# **DART SERVICE INSTRUCTION**

TO AMEND INSTALLATION INSTRUCTIONS D206-642 REV. L AND  
INSTRUCTIONS FOR CONTINUED AIRWORTHINESS ICA-D206-642 REV. 1

B	P/N CORRECTION	AJS	09.03.25
A	NEW ISSUE	AJS	08.12.19
REV.	DESCRIPTION	BY	DATE
DESIGN	AJS	<b>DART AEROSPACE LTD</b> HAWKESBURY, ONTARIO, CANADA	
DRAWN	AJS		
CHECKED		DRAWING NO.	REV. B
MFG. APPR.	N/A	DSI 9440	SHEET 1 OF 4
APPROVED		TITLE	SCALE
DE APPR.		WEARSHOE CHANGE	NTS
DATE	09.03.25	COPYRIGHT © 2008 BY DART AEROSPACE LTD <small>THIS DOCUMENT IS PRIVATE AND CONFIDENTIAL AND IS SUPPLIED ON THE EXPRESS CONDITION THAT IT IS NOT TO BE USED FOR ANY PURPOSE OR COPIED OR COMMUNICATED TO ANY OTHER PERSON WITHOUT WRITTEN PERMISSION FROM DART AEROSPACE LTD.</small>

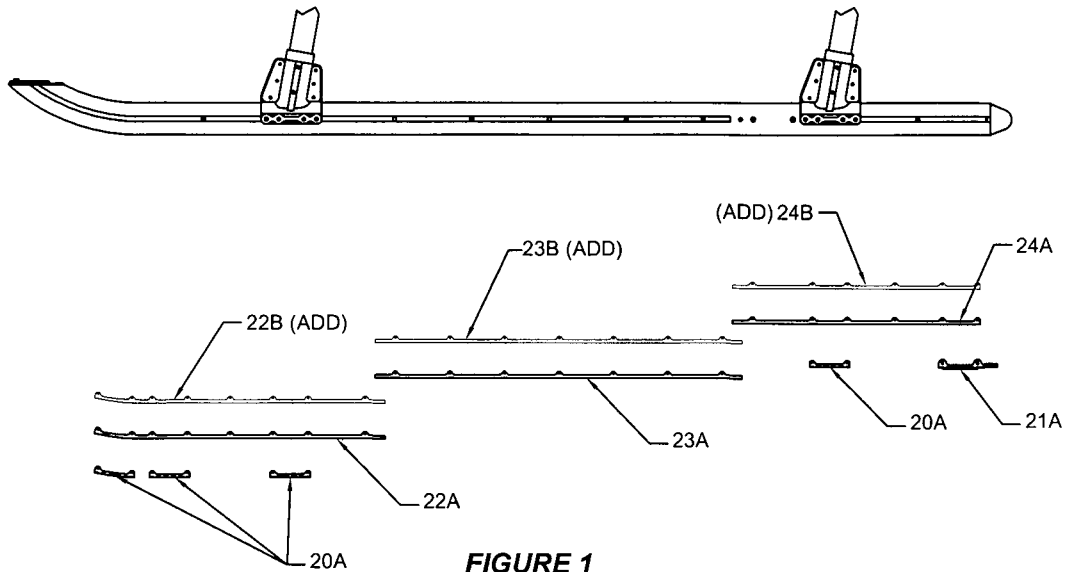
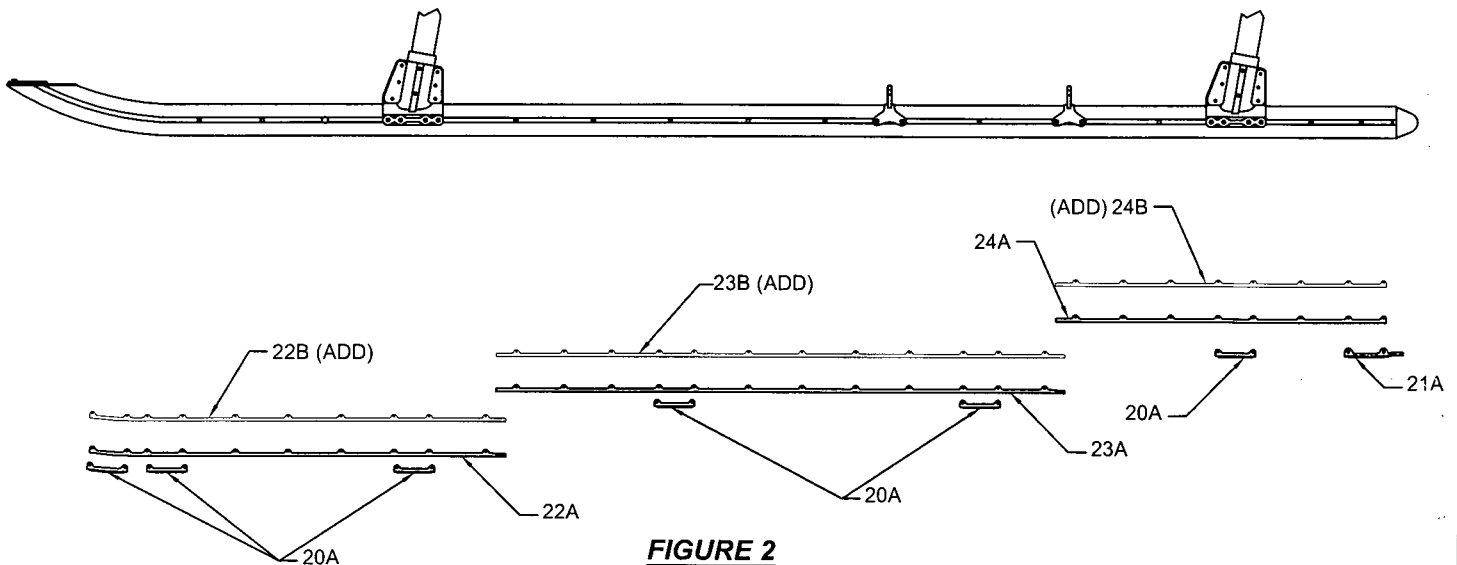
- 2) FOR D206-642-311/-312/-411/-412 SKIDTUBES @ CHANGE 006 AND SUBSEQUENT, MODIFY THE FOLLOWING:
- a) REPLACE THE CARBON STEEL WEAR PADS AND WEARSHOES WITH STAINLESS STEEL WEARPADS AND WEARSHOES PER THE UPDATED PARTS LIST ON SHEET 3.

- b) ADD NEOPRENE GASKETS BETWEEN THE SKIDTUBE AND WEARSHOES PER THE UPDATED PARTS LIST ON SHEET 3 AND PER FIGURE 2 ON SHEET 4.
  - c) REPLACE THE CARBON STEEL FASTENERS FOR THE WEARPADS AND WEARSHOES WITH STAINLESS STEEL FASTENERS PER THE UPDATED PARTS LIST ON SHEET 3.

- d) AMEND THE PARTS LIST IN SECTIONS 4.3 AND 4.4 OF INSTALLATION INSTRUCTIONS D206-642 REV. L OR EARLIER AND SECTIONS 32.12 AND 32.13 OF THE INSTRUCTIONS FOR CONTINUED AIRWORTHINESS ICA-D206-642 REV. 1 OR EARLIER AS SHOWN ON SHEET 3.

20A			6			D3537-1	WEARPAD (REPLACES D2648-3)	(MODIFY)
21A			1			D3537-3	WEARPAD (REPLACES D3429-1)	(MODIFY)
22A			1	1		D3535-15	WEARSHOE (REPLACES D2656-15)	(MODIFY)
22B			1	1		D3536-15	GASKET	(ADD)
23A			1	1		D3535-23	WEARSHOE (REPLACES D2656-23)	(MODIFY)
23B			1	1		D3536-23	GASKET	(ADD)
24A			1	1		D3535-37	WEARSHOE (REPLACES D2656-37)	(MODIFY)
24B			1	1		D3536-37	GASKET	(ADD)
26A			60			MS27039-1C08	SCREW	(MODIFY)
26B			60			AN960C10L	WASHER	(MODIFY)

20A			6			D2648-3	WEARPAD
21A			1			D3429-1	WEARPAD
22A			1	1		D2656-15	WEARSHOE
23A			1	1		D2656-23	WEARSHOE
24A			1	1		D2656-37	WEARSHOE
26A			60			MS27039-1-08	SCREW
26B			60			AN960JD10L	WASHER
